### APPEAL SUMMARY

<b>Appeal ID:</b> 23297	<b>Project Address:</b> 555 SE MLK Jr Blvd
<b>Hearing Date:</b> 1/8/20	<b>Appellant Name:</b> Daniel Hannah
<b>Case No.:</b> M-001	<b>Appellant Phone:</b> 5036799879
<b>Appeal Type:</b> Mechanical	<b>Plans Examiner/Inspector:</b> Kent Hegsted, Ali Soheili
<b>Project Type:</b> commercial	<b>Stories:</b> 6 <b>Occupancy:</b> Commercial Office <b>Construction Type:</b> Commercial
<b>Building/Business Name:</b> District Office	<b>Fire Sprinklers:</b> Yes - Entire Building
<b>Appeal Involves:</b> Reconsideration of appeal	<b>LUR or Permit Application No.:</b> 17-208768-REV-03-MT
<b>Plan Submitted Option:</b> pdf [File 1] [File 2] [File 3] [File 4] [File 5]	<b>Proposed use:</b> Office Space

Date:	December 31, 2019
To:	Caliber Plumbing & Mechanical 6036 N Cutter Circle, Suite 360 Portland, OR 97217 Sent via Email
Attention:	Daniel Hannah Project Manager/Estimator
From:	David Gessert, P. E. Fire Protection Engineer
Subject/Project:	Eastside Office 555 SE Martin Luther King Blvd Appeal – Exhaust Duct Fire Resistance
Job No.:	2019-57

**MECHANICAL CHECKSHEET****Mechanical Permit**Application # : **17-208768-REV-03-MT**Review Date: **November 6, 201

**DETAIL AT SHAFT TOP**  
NO SCALE

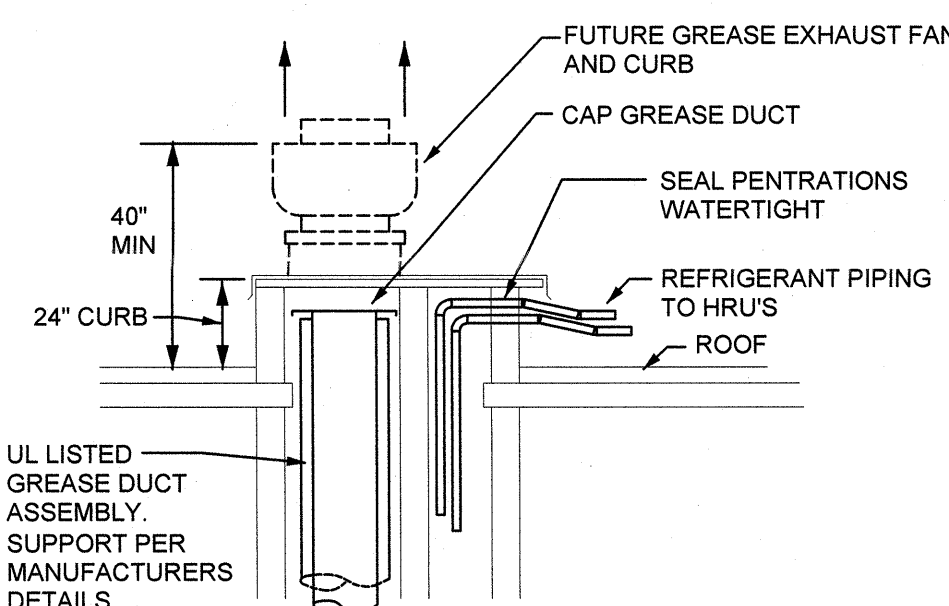
Detail of method of duct penetration of rated shaft with firewrap has been added to the drawing M-110 and is stamped by an Oregon registered engineer. The one registered Fire Protection engineer was not going to be available in a timely manner to look at this.

The detail in the upper left-hand portion of the drawing shows the 2-hour fire resistance protection for the 12x16 duct from the gypsum shaft assembly and terminating above the roof line. This 2-hour fire resistance protection is achieved using 3M Fire Barrier Duct Wrap, 3M Fire Barrier Sealant, and related accessories. Design and installation of the 2-hour fire resistance material is to be in accordance with Design No. 3MU/DI 120-01, Ventilation Duct Protection.

Where an unwrapped duct passes through rated construction the annular space is sealed with unfaced ceramic insulation and fire caulk. Then the duct wrap is butted against the annular seal and rated construction. See Design No. 3MU/DI 120-01, Ventilation Duct Protection.

5.	M-110	<p>2014 OMSC</p> <p>106.3.1</p> <p>607.5.5</p> <p>Exception</p> <p>1.1 &amp; 2</p>	<p>Job description is indicating removing fire dampers and sub-ducts. Details in M-110 does not match the description, clarify.</p> <p>11/13/19: Your comment indicating sheet M-110 showing the sub-duct system. The details shown, is connecting ducts to a duct riser and do not meet the requirement of sub-duct system. Refer to OSSC chapter 6 and chapter 9 for requirement of sub-duct system.</p> <p><b>11/25/19 Recheck 02: Not resolved.</b></p> <p>As noted on 11/6/19 and 11/13/19 The details shown do not meet the requirements of a subduct system. See 607.5.5 Exception 1.1 &amp; 2.</p> <ul style="list-style-type: none"> <li>a) Please provide calculations for duct sizing. Show that the cross-sectional area of the main duct is large enough so that the subduct does not excessively restrict the airflow from below.</li> <li>b) Specify a minimum thickness of 26 gage for the subducts.</li> <li>c) The 2-hour rated shaft rating that these ducts exhaust through must be maintained. 2 hour rated horizontal assemblies are required where they connect with EF-1. Fire wrap is not an approved alternative.</li> <li>d) EF-1 must be powered continuously. Identify the source for standby power and clearly identify on the plans that the fan must run continuously.</li> </ul> <p><b>12/17/19 Recheck 03: Not resolved.</b></p> <p><b>Appeal ID 22211 is on Hold for additional information. Please contact John Butler 503-823-7339 with questions.</b></p>

**1a. Use of grease duct wrap as 2 hour protection of horizontal duct run: Granted provided duct wrap installation is per manufacturers specifications.**

**1b. Omission of fire damper at 6th floor through penetration of 2 hour shaft with engineering analysis: Granted as proposed.**

**D FIRE SUBDUCT SECTION**  
M-110 NO SCALE

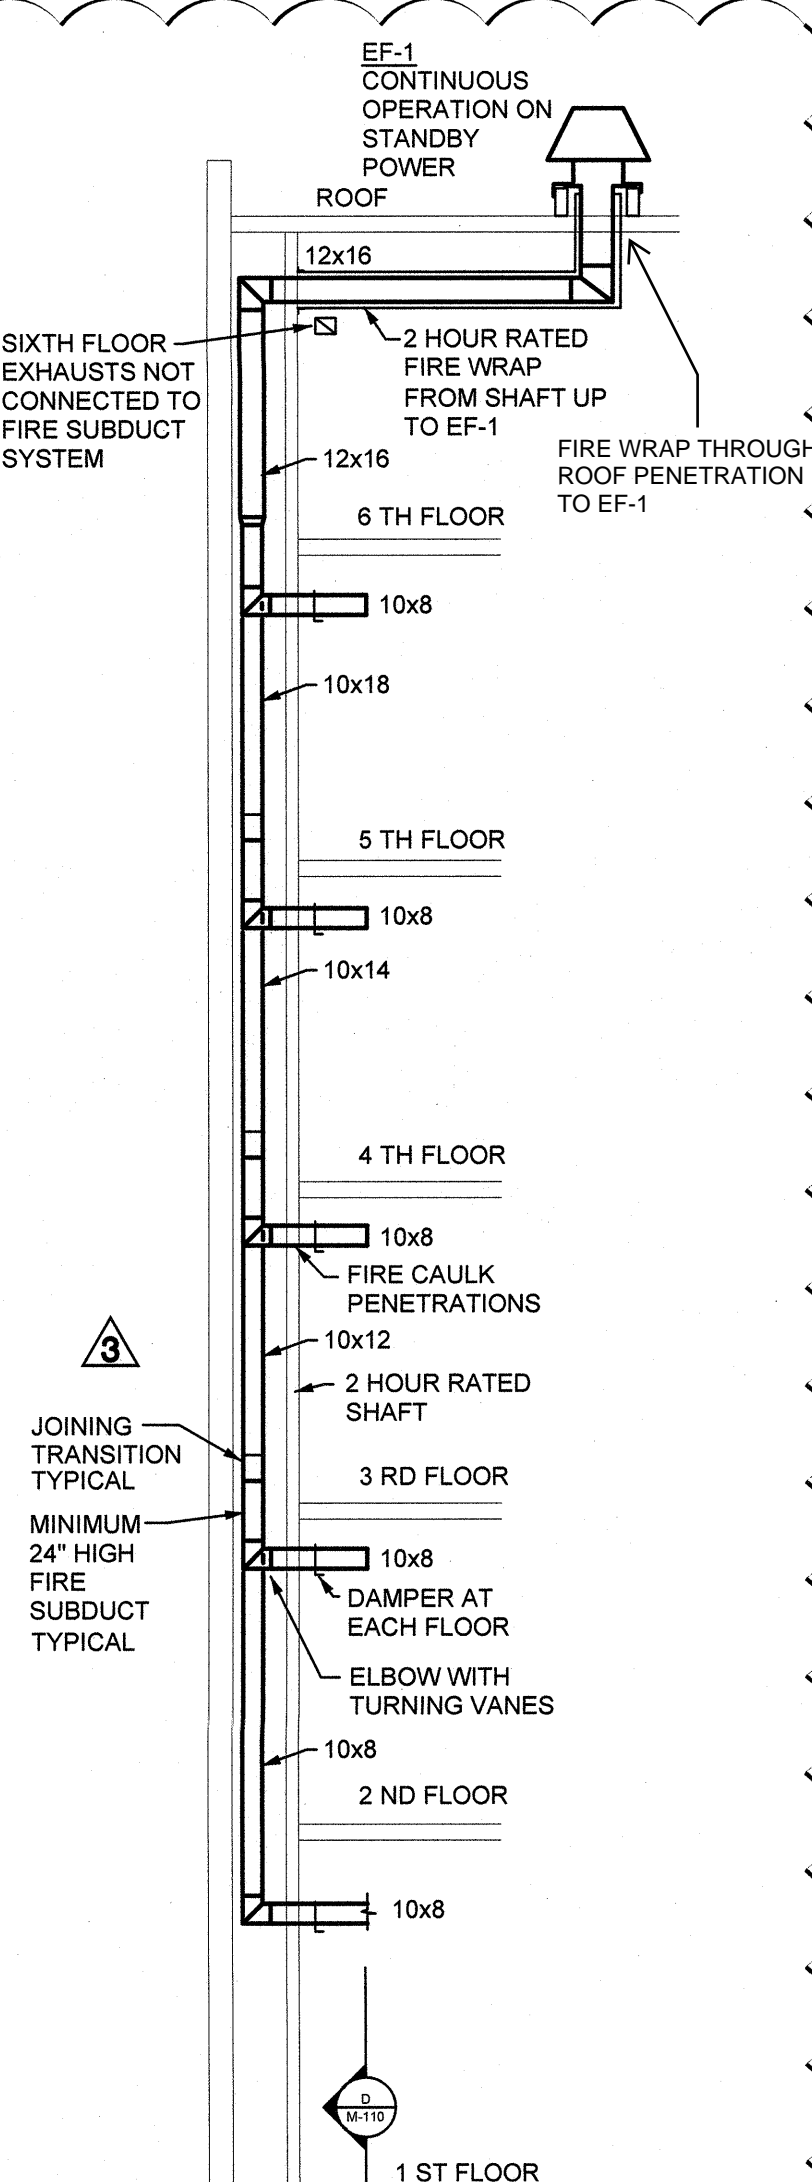
<b>Code Section</b>	OMSC 607.5.5. Exception 1.1.
<b>Requires</b>	<p>Fire Dampers are not required at penetrations of shafts where:</p> <p>1.1.:Steel exhaust subducts extend at least 22 inches vertically in exhaust shafts provided that there is continuous airflow upward to the outdoors</p>
<b>Proposed Design</b>	<p>We propose to use an approved 2 hour rated fire duct wrap installed per the manufacturer's installation instructions to enclose the exhaust duct from the shaft penetration horizontally to the location of the roof exhaust fan and up through the roof to the fan.</p> <p>All other portions of the fire subduct assemblies at each floor comply with the exception 1.1. Per specifications all ductwork is a minimum 26 gage. The roof exhaust fan for this system is connected to the emergency standby power so that it runs continuously.</p>
<b>Reason for alternative</b>	<p>Due to limited ceiling space there is not adequate room to build a two hour rated duct enclosure in the horizontal offset.</p> <p>Listed Fire Wrap is generally listed and approved in lieu of fire rated shafts for grease exhaust ducts and higher hazard conditions that the toilet exhaust ducts that we have in this building at this location.</p> <p>It has been appealed and approved in the past for similar conditions. (Appeal #18939)</p> <p>Response to Checksheet Note 5 and additional information for appeal 22211 on Hold:</p> <p>The fire subduct system does meet the requirements as designed. We added another section detail D / M-110 to make it more clear. Subducts do extend at least 22 inches up before attaching to exhausts duct riser.</p>

1 Roof  
M-110  $1/8'' = 1'-0''$

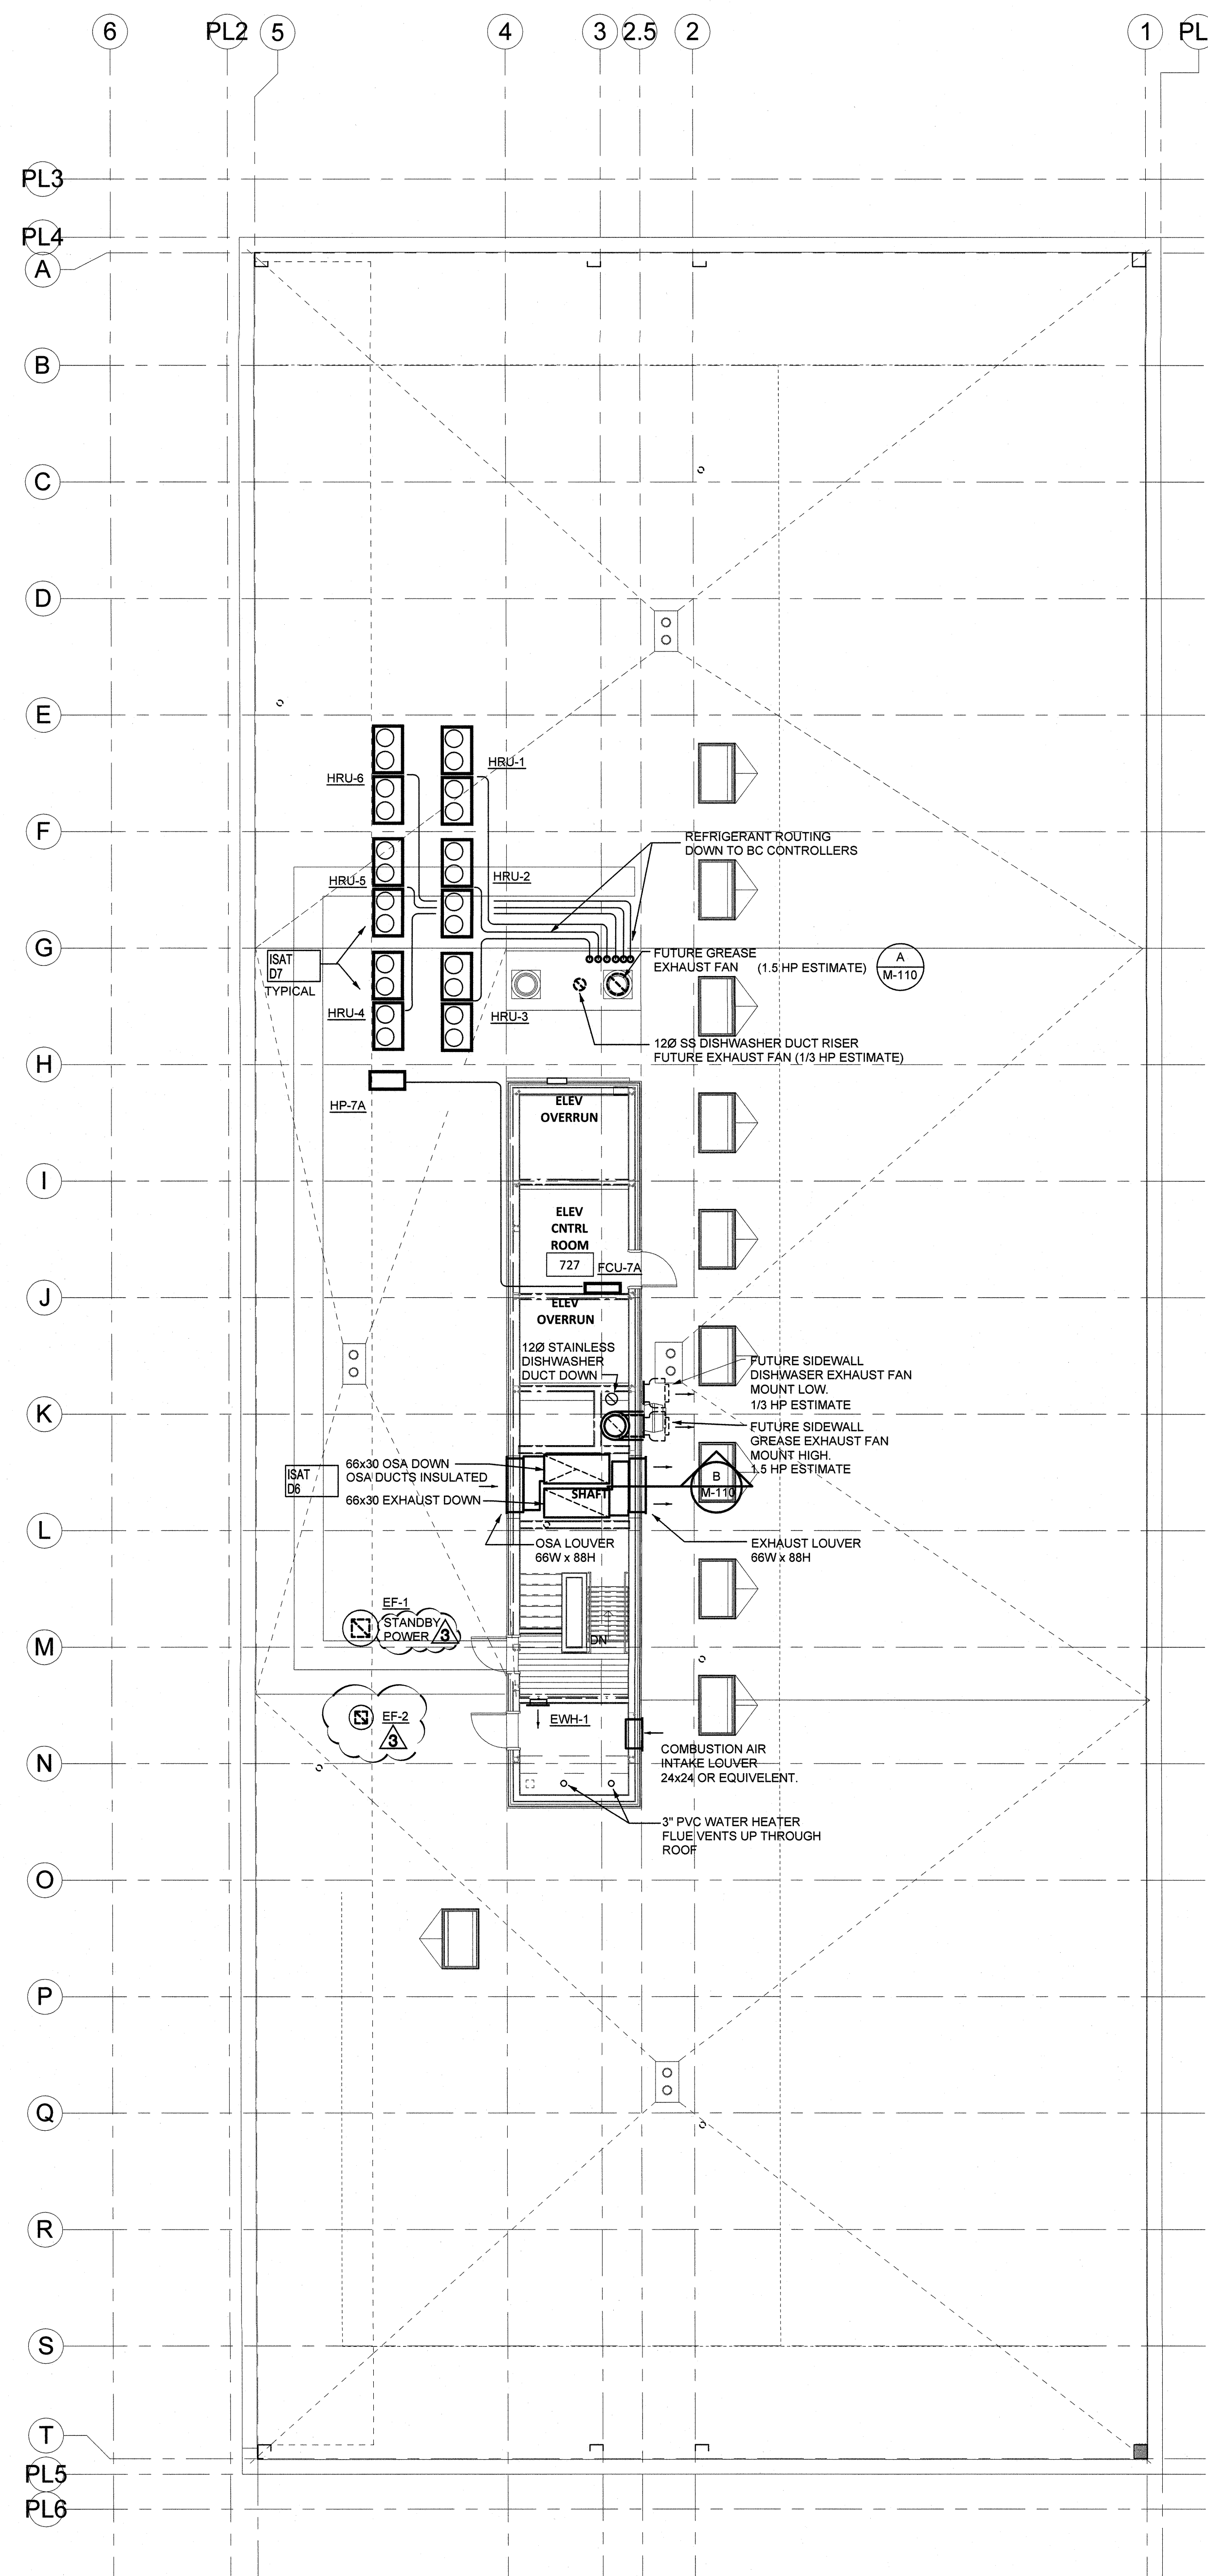
6.	M-110	<p>2014 OMSC</p> <p>Chapter 5</p>	<p>Future exhaust fan discharge shall be at least 10' from the skylight openings.</p>
7.			
8.			
9.			
10.
